Access Compliance Report

Public Rights-of-Way

(Curb Ramps)

Intersection ID: 45248	Main Street: CALDWELL_RD	Cross Street: SUNBURST_LN	Location:	N
ADA ID: 6912A28DE6EB	Ramp Type: Perp	Initial Pass/Fail: Fail	Overall Compliance: No	Severity Score: 8.75
Codes/Mitigation Info/Possible Solution		Field Measurements/Component Compliance

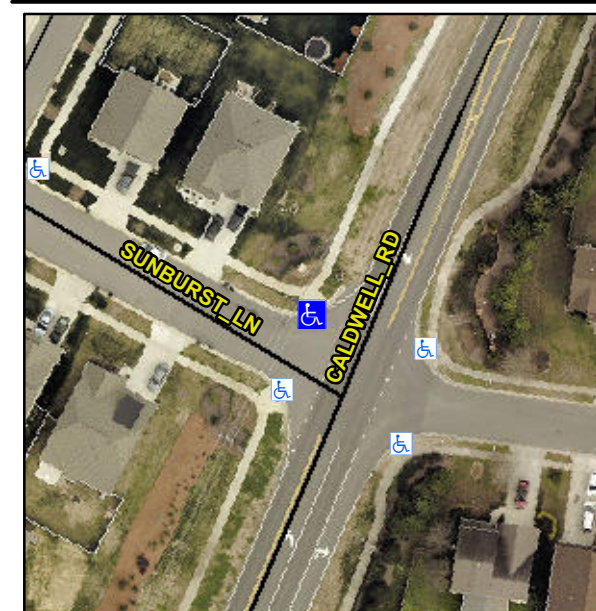
Not Found, R304.5.1

Compliance	Description	Data	Compliance	Description	Data
N/A	Ramp Length (in)	96.0	Yes	Ramp Slope (%)	6.7
No	Ramp Width (in)	46.5	Yes	Ramp XSlope (%)	0.6
N/A	Flare Type LT	N/A	N/A	Flare Type RT	N/A
N/A	Flare Slope LT (%)	N/A	N/A	Flare Slope RT (%)	N/A
N/A	Flare Traversable LT?	N/A	N/A	Flare Traversable RT?	N/A
N/A	Landing Length (in)	N/A	N/A	DWS Provided?	N/A
N/A	Landing Width (in)	N/A	N/A	DWS Contrast?	N/A
N/A	Landing Slope (%)	N/A	N/A	DWS Length (in)	N/A
N/A	Landing X Slope (%)	N/A	N/A	DWS Full Width?	N/A
N/A	Landing Curb? (Y/N)	N/A	N/A	DWS Offset (in)	N/A
N/A	Shared Landing?	N/A			
N/A	Gutter Ponding?	N/A	N/A	Gutter Slope (%)	N/A
N/A	Gutter Lip Ht (in)	N/A	N/A	Gutter X Slope (%)	N/A
N/A	Painted X Walk1?	No	N/A	Painted X Walk2?	N/A
	X Walk 1 Direction	To W		X Walk 2 Direction	N/A
N/A	X Walk 1 Width (in)	N/A	N/A	X Walk 2 Width (in)	N/A
	X Walk 1 Slope (%)	0.4		X Walk 2 Slope (%)	N/A
	X Walk 1 X Slope (%)	1.6		X Walk 2 X Slope (%)	N/A

Remove & Replace Entire Ramp.
